MEMORANDUM

Our Ref: ENV/DC/PP/2015/0812

Location: O. S Grid Ref: 330 513 Land North of Total Fitness Ltd, Stansty Road, Wrexham.
Development: Residential Development (24 no. dwellings) together with highways, access and parking arrangements.

I refer to the email dated 03/12/2015 from Singleton Clamp including Technical Note (PT/15246/TN01) in respect of the above.

Turning Areas

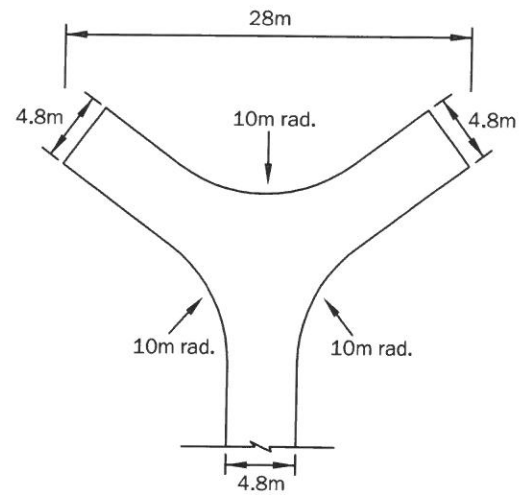
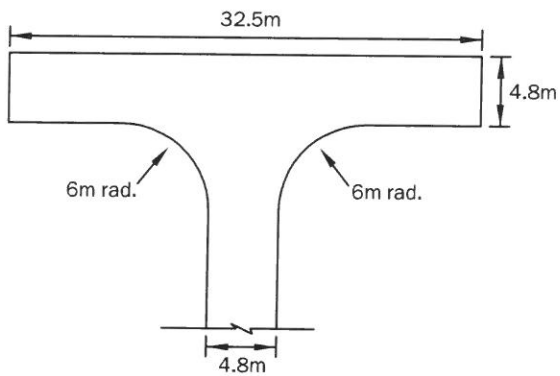
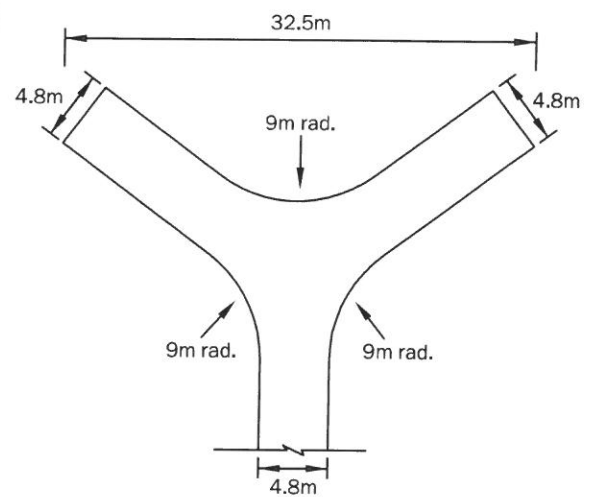
Please find attached WCBC Standard turning head detail that needs to be incorporated on a revised layout plan.

7.5t Panel Van

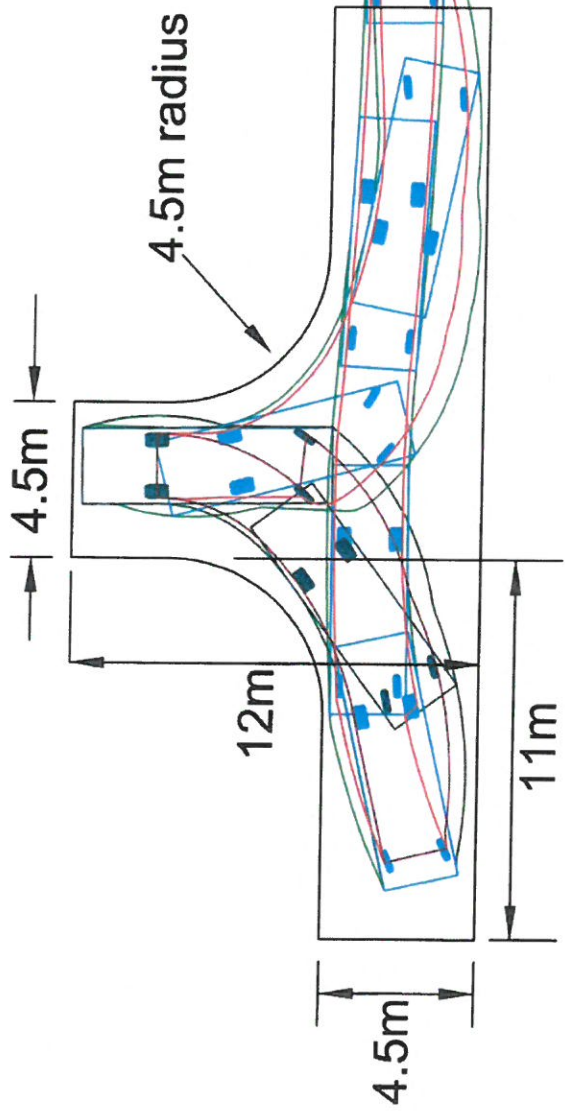
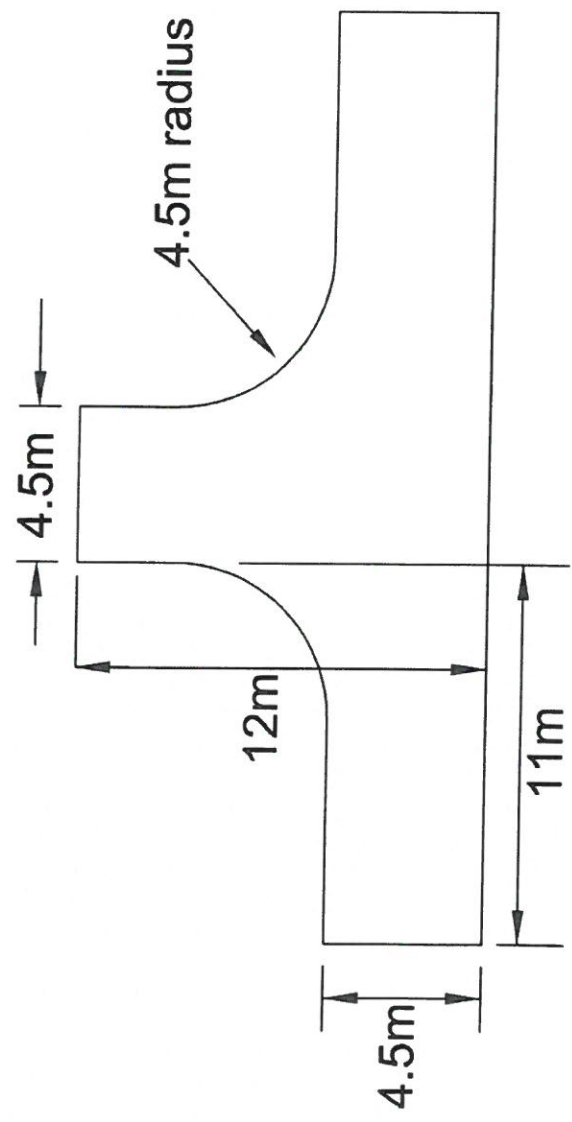
The private driveway serving plot nos. 1 – 6 has no turning head. I would recommend that this driveway is provided with a suitable turning head to accommodate the turning movements of a medium sized HGV (see attached detail).
